AES-0-NRC-09-00055-0

AREVA Enrichment Services LLC
Eagle Rock Enrichment Facility
NRC Docket No: 70-7015

Subject: Notice of Organization Change for the Eagle Rock Enrichment Facility
License Application

Attachment 1 – AES Organization Change, Marked-up Pages for the Safety Analysis Report and Quality Assurance Program Description

Figure A-2 **Rev. 1a**
 Engineering, Procurement and
 Construction (EPC) Organizational Chart
EAGLE ROCK ENRICHMENT FACILITY
QUALITY ASSURANCE PROGRAM DESCRIPTION

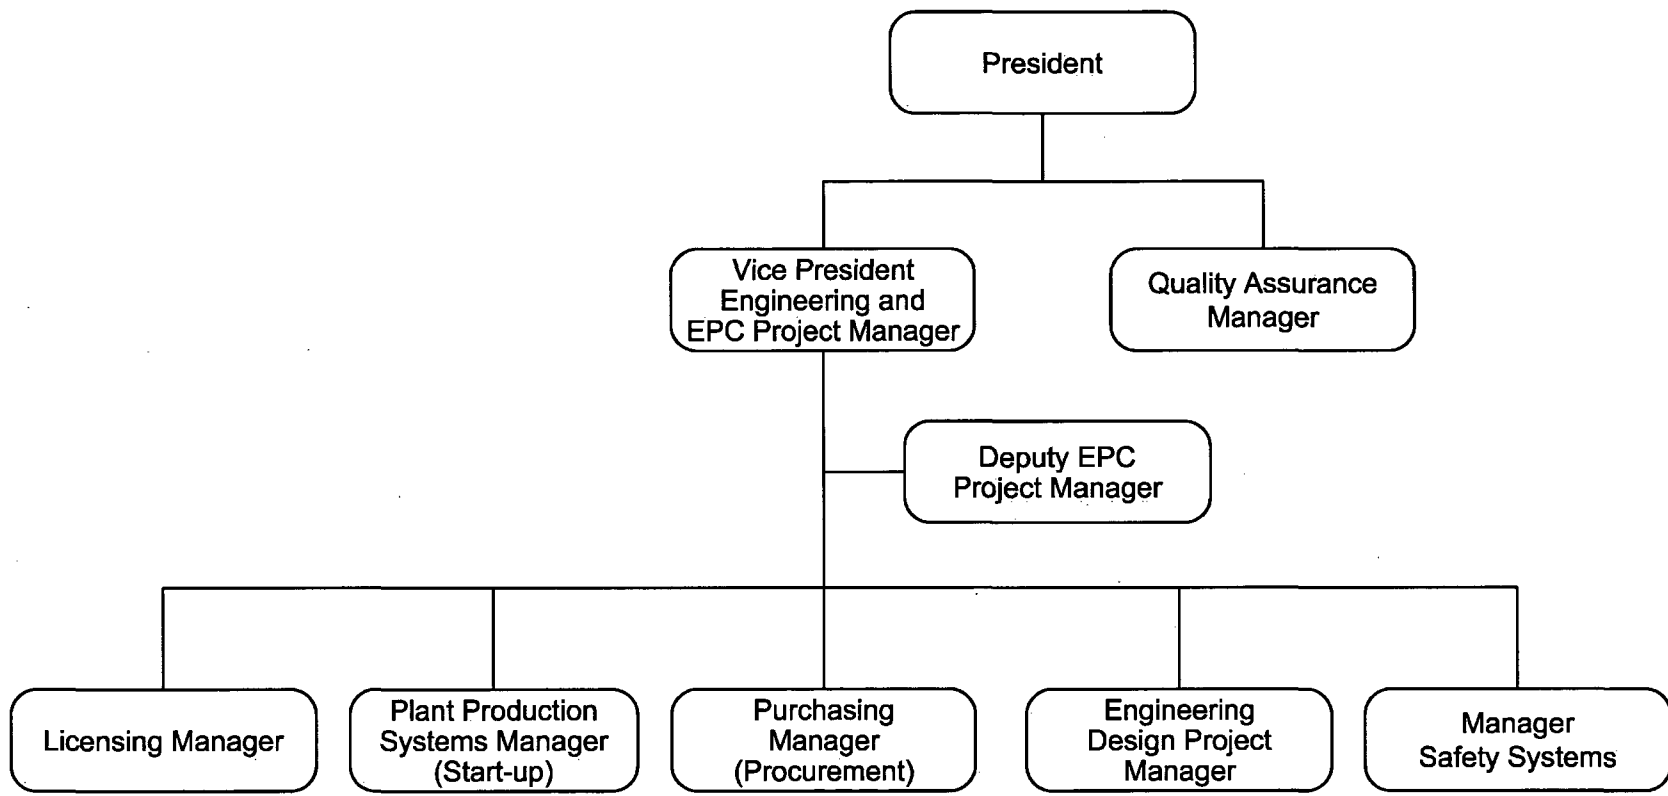
On April 23, 2009, AREVA Enrichment Services LLC (AES) submitted a revised License Application to the U.S. Nuclear Regulatory Commission (NRC) to construct and operate the Eagle Rock Enrichment Facility (EREF) in Bonneville County, Idaho. Section 19.2 of the Quality Assurance Program Description (QAPD) requires AES to notify the NRC of an organization change which affects the QA Program within 30 days of implementation of the organization change. The changes to the EREF Safety Analysis Report (SAR) and the QAPD were implemented on May 15, 2009 and are provided in Attachment 1. The organization changes maintain alignment with the evolving scope of responsibility to license, design, build and operate the EREF. The changes to the QAPD do not constitute a reduction in commitment.

The Vice President Engineering and EPC Project Manager is responsible for managing the work and contracts with ETC. Also reporting to the Vice President Engineering and EPC Project Manager are the individuals responsible for the areas of procurement, construction, engineering and design, licensing, safety systems, and start-up. The lines of communication of key management positions within the engineering, procurement and construction organization are shown in Figure A-2 of the QAPD.

1.1.3 Figure A-2 of the QAPD shows the engineering, procurement, construction, and initial start-up organization of the EREF.
